UNITED STATES ENVIRONMENTAL PROTECTION AGENCY

RE: MCB Camp Lejeune NPL Site  
Camp Lejeune, North Carolina

EPA Comments on the Interim Action  
Proposed Plan for The Shallow Aquifer  
Hadnot Point Industrial Area  
Marine Corps Base  
Camp Lejeune, North Carolina

EPA Comments on the Interim Action  
Remedial Investigation for The Shallow Aquifer  
Hadnot Point Industrial Area  
Marine Corps Base  
Camp Lejeune, North Carolina

Figure 1 Camp Lejeune capture zone- 5 yrs at 100 ft<sup>3</sup>/d

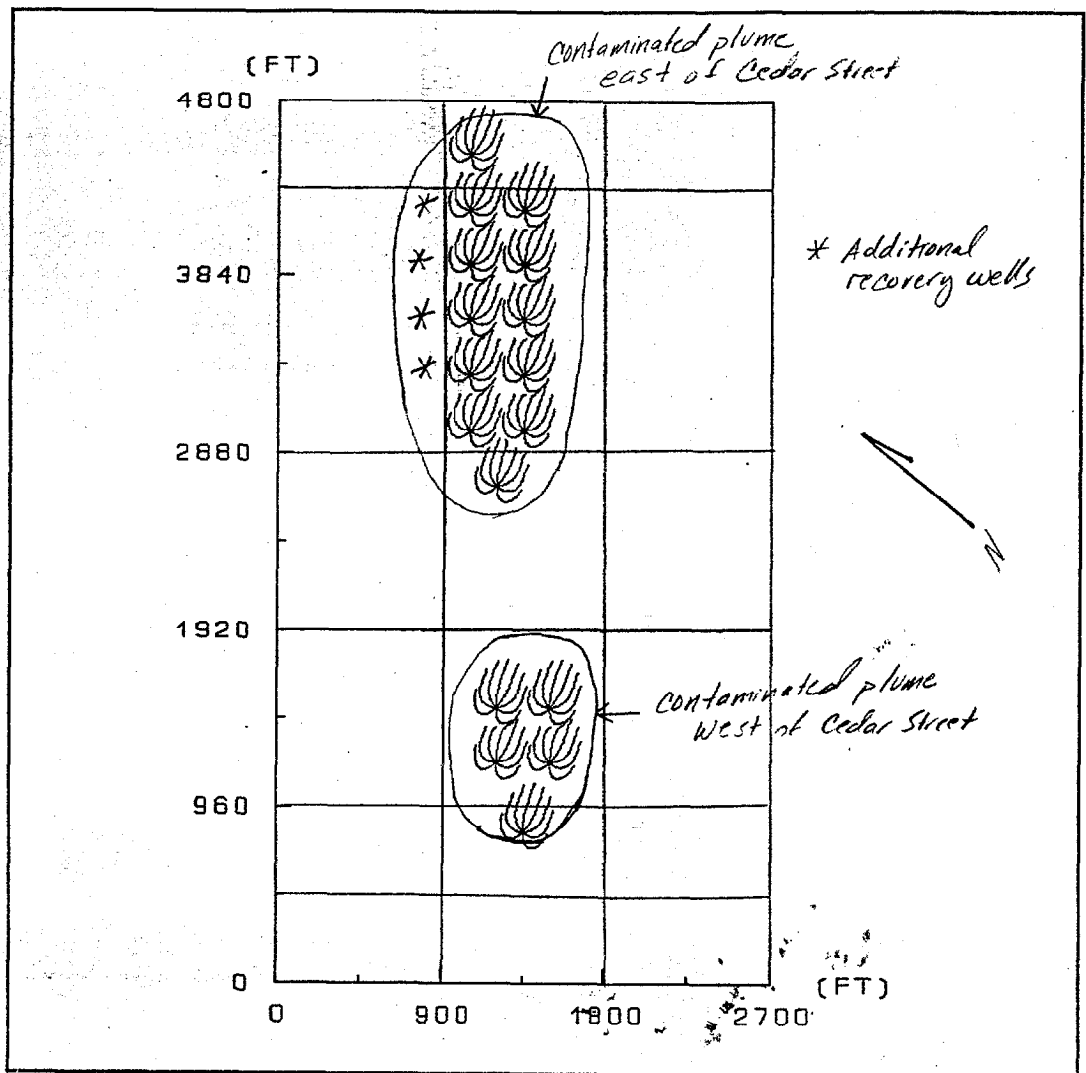
The WHPA General Particle Tracking Module (GPTRAC) semi-analytical option was applied to simulate the capture zones using recovery wells in the configuration shown in figure 1. These wells are spaced 300 feet apart in the northeast-southwest direction and 300 feet apart in the northwest-southeast direction. The data set created for the model was taken from information provided in the Feasibility Study. These data applied include: transmissivity, 66 ft<sup>2</sup>/d; hydraulic gradient 0.003 ft/ft; and saturated thickness, 20 ft. The porosity of the aquifer is not discussed in the documents, but a value of 10 percent was assumed based on the lithology of the aquifer. The areal recharge rate was estimated based on the annual precipitation, evapotranspiration, and surface runoff. The estimated value used for the areal recharge rate was 7 inches/year.

As shown in figure 1, the capture zones of the 17 recovery wells nearly cover the areas contaminated in the shallow aquifer. The capture zones depicted are for a 5 year period with each well pumping at 100 ft<sup>3</sup>/d. This model indicates that to capture all contaminated ground water in the large plume, 3 to 4 additional recovery wells should be installed along the west side of the plume (see figure 1). A maximum of 21 wells installed in this configuration should capture the contaminated plume within a 5 year period. This design is more cost effective than installing 32 wells as proposed in the Focused Feasibility Study. Alternatively, the 17 wells could be shifted to the southwest to the point that the capture zones encompass the entire plume; this alternative would not necessarily create capture of the entire plume within 5 years as would addition of 3 to 4 more wells.

The recovery well configuration appears to be successful in remediating the contaminated plume. Other recovery well configurations may be proposed that involve fewer wells with higher pumping rates. If possible the shallow aquifer and the Castle Hayne aquifer should be remediated simultaneously to prevent large differences in head between the aquifers and maintain a small vertical hydraulic gradient. This will minimize ground-water communication and subsequent contaminant migration between the aquifers.

In summary, a computer model such as WHPA should be applied to determine appropriate recovery well locations. This approach is good for designing a successful extraction system and should prove to be cost effective. Other remedial alternatives should be considered that will treat the contaminants of concern to appropriate discharge criteria.
